CITY OF ALBUQUERQUE

RE: Element Hotel
2440 Louisiana Blvd. NE
Grading and Drainage Plan
Engineer's Stamp Date: 06/25/21
Hydrology File: H19D087

ELEMENT HOTEL
2440 LOUISIANA BLVD NE

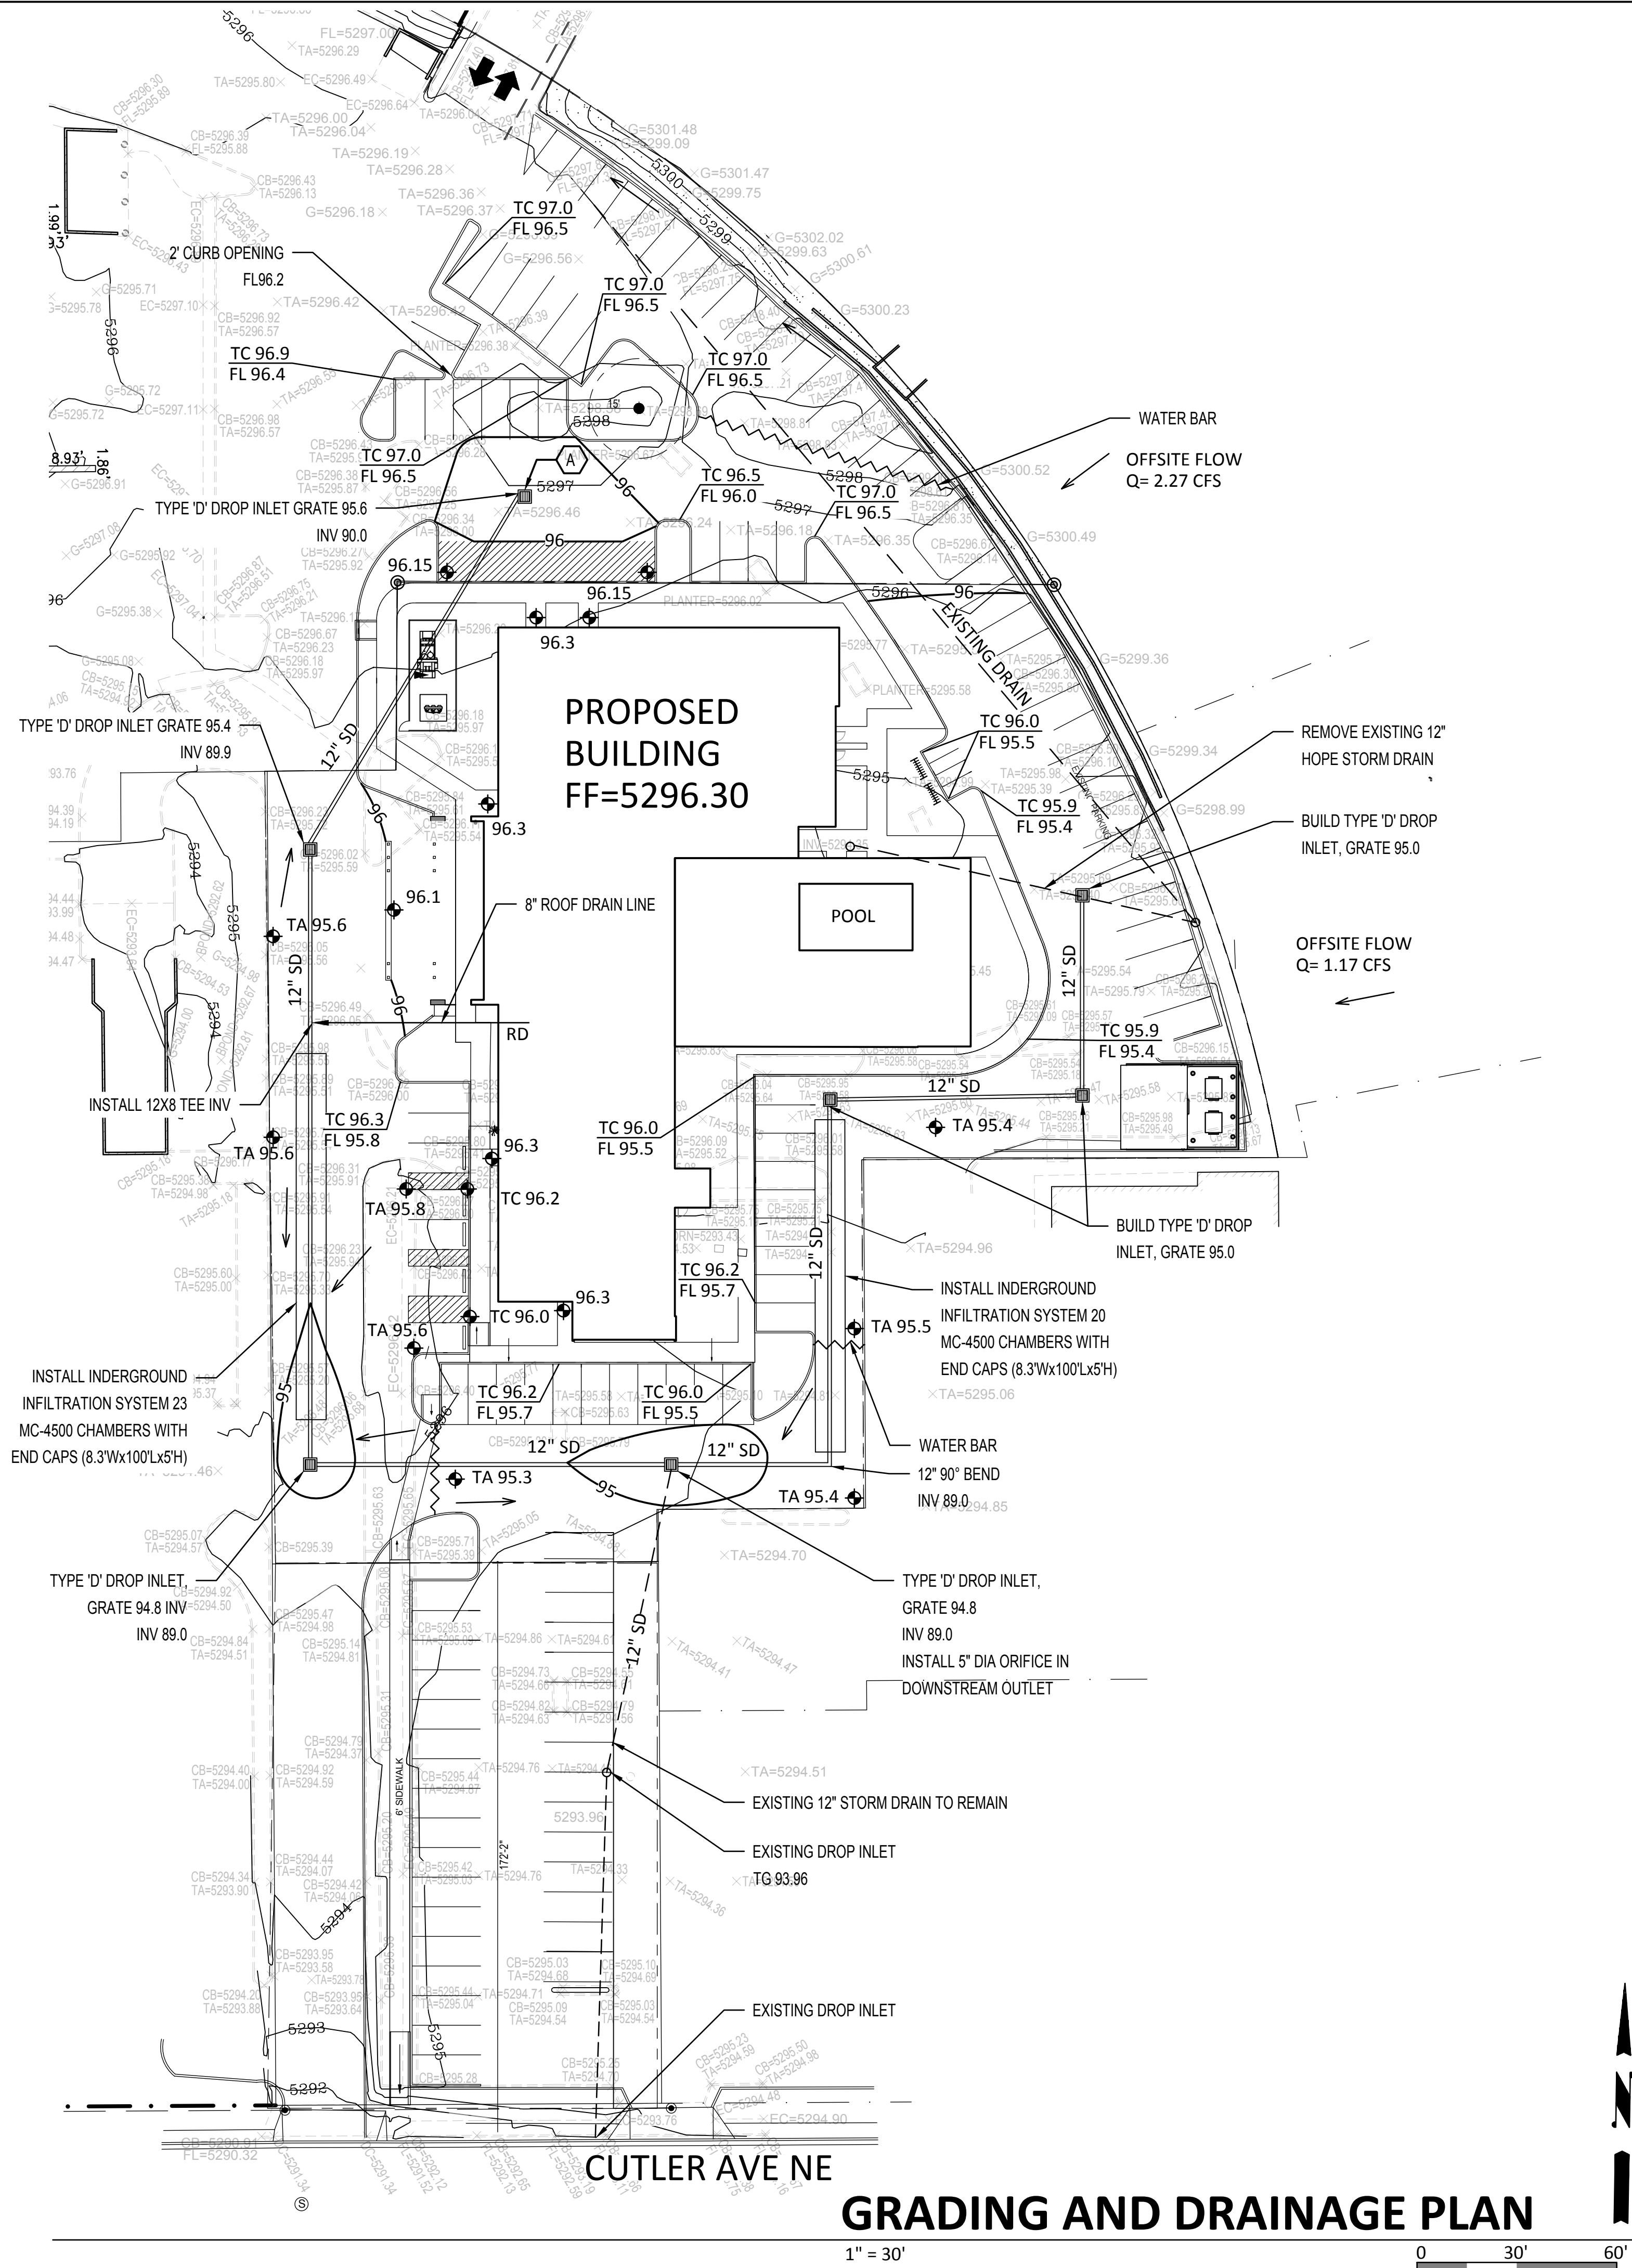
1. It is unclear what is being constructed and what is existing. In places the line work for the existing is the same line weight as proposed. There appears to be existing contour lines and proposed contour lines but again there is no clear what is what. Please clean this up.

2. Please show the edge of saw cut of the existing pavement and label along this, "Match existing grades". It is currently unclear where the area of construction is starting/stopping.

3. There also seems to be not enough proposed grade points to build this. I reviewed the approved Conceptual G&D and there were defiantly more points than this Grading Plan.

4. Please add the legal description of the adjacent property that contributes to the noted offsite flows.
5. Under the drainage calculations, please add some separation in the calculations. They almost seem to run on from the Stormwater Quality calculations to the underground retention calculations. It is a little hard to follow.

6. Please indicate on the Grading & Drainage Plan where the surface storage of 3,200 CF is being held.
7. Please indicate the location of the 5-in orifice located. Is it on the end cap of the underground chamber system? Or is it an orifice plate within the drop inlet?
